**SUBDIVISION &  
ZONING AMENDMENT STAFF REPORT****Date: May 19, 2005****SUBDIVISION NAME**

Mobile Medical Group Subdivision

**LOCATION**6001 Airport Boulevard  
(East side of Wildwood Avenue, 165' South of Airport  
Boulevard)**CITY COUNCIL  
DISTRICT**

REQUEST Rezoning from R-1 to B-1, Subdivision

# SITE PLAN

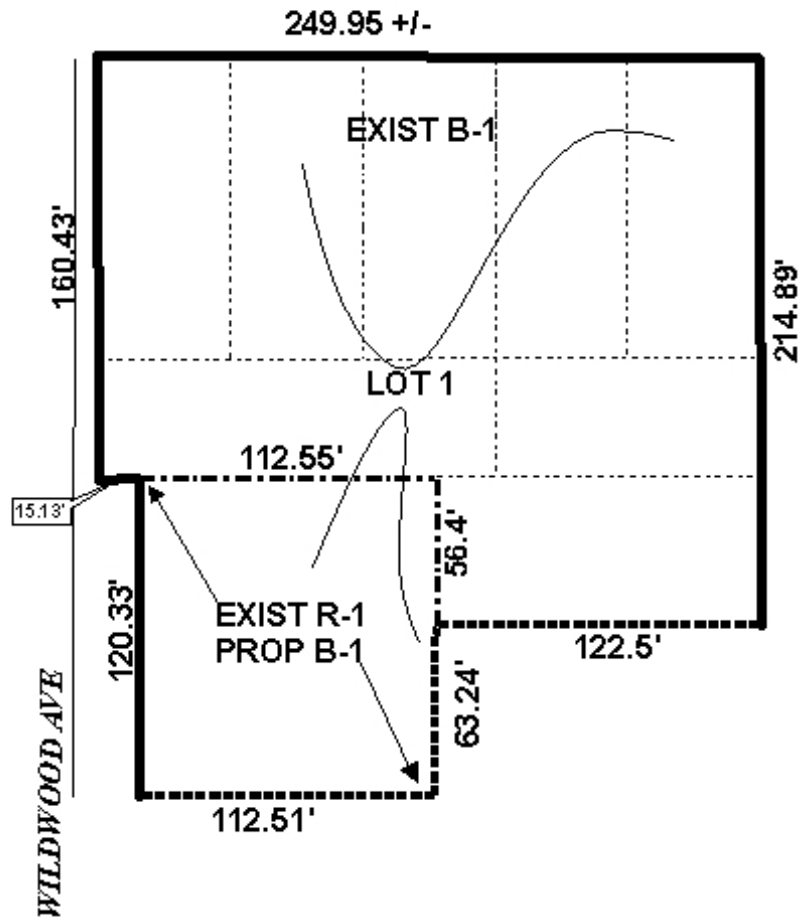
The medical facility fronts Airport Boulevard, with a 140' right-of-way, Pinemont Avenue, with a 60' right-of-way, and the substandard right-of-way of Wildwood Avenue, which has not been constructed adjacent to the site; sufficient right-of-way to provide 25' from the centerline of the Wildwood Avenue right-of-way would be required. With the rezoning of the R-1 lot, the plat would meet the minimum requirements of the Subdivision Regulations.

Surrounding lots are zoned both R-1 and B-1, so rezoning would be consistent with the surrounding area. However, as the commercial use would abut residential properties, a buffer would be required, per Section V.A.7 of the Subdivision Regulations and Section IV.D.1 of the Zoning Ordinance.

While the required 25' minimum building setbacks are not shown, they would be required on the final plat.

It should be noted that, while a subdivision plat was submitted for the rezoning application instead of a site plan, the site must nevertheless comply with Section VI.A (parking requirements) of the Zoning Ordinance.

**Subdivision** Based on the preceding, the plat is recommended for Tentative Approval subject to the following conditions: 1) completion of the rezoning process prior to the issuance of any permits; 2) the dedication of sufficient right-of-way to provide 25' from the centerline of the Wildwood Avenue right-of-way; 3) the provision of a buffer between the site and residential properties, in compliance with Section V.A.7 of the Subdivision Regulations; 4) the depiction of the 25' minimum building setback lines on the final plat; and 5) the placement of a note on the final plat stating that the site is denied access to Wildwood Avenue.
